# MC9S08DZ60 Migrating from the 3M05C to M74K Mask Set

This document addresses the differences between the two mask sets, 3M05C and M74K. This application note does not describe in detail how to use the DZ60 in a particular system. It highlights the differences from the earlier mask set versions and provides guidance in migrating code. Programmers and designers must consult the specific HCS08 MCU data sheet for further information on using and programming the device. This application note also refers to errata data *PWM Boundary Case Issues in HCS08 Timer PWM Module (TPM)*

Figure 1. IIC Control Register (IICC2)

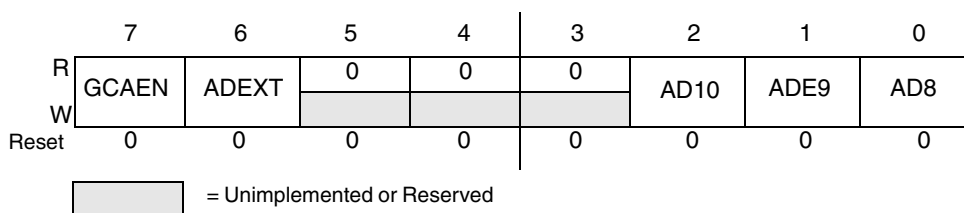
The inter-integrated circuit (IIC) peripheral on the M74K offers all the functionality of the 3M05C IIC, while fixing the 10-bit addressing mode errata.

This 10-bit addressing mode is enabled via the IICC2 register.

The IICC2 register controls the general call address function and the 10-bit address extension.

**Figure 2. Master–Transmitter Addresses Slave–Receiver with a 10-bit Address**

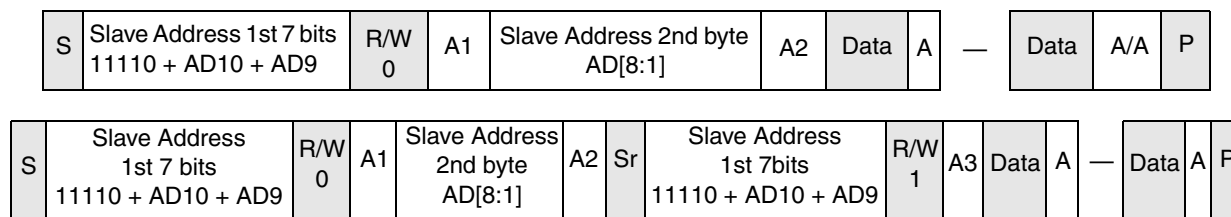
When the 10-bit extended address is enabled, the protocol for initiating data transfers via the IIC is slightly changed.

In the case of a master transmitter data transfer of two address bytes are required to address the slave. The first address byte always has 0x11110 as its first 5 bits, followed by address bits AD10 and AD9 then the data direction bit. The second address byte consists of the remaining address bits (AD8:1). Once both address bytes have been successfully acknowledged then the master can begin to transmit data to the slave.

For a master receiver data transfer the protocol is more complicated. In this case three address bytes are necessary to address the slave. The first two address bytes are configured exactly as the master transmit data transfer. After these two bytes have been successfully acknowledged, a repeated start signal is sent and the first address byte is resent, but this time with the data direction bit configured to indicate that the slave must transmit data to the master receiver.

A summary of the 10-bit extended address protocol is shown below for both a master transmitter and master receiver data transfers.
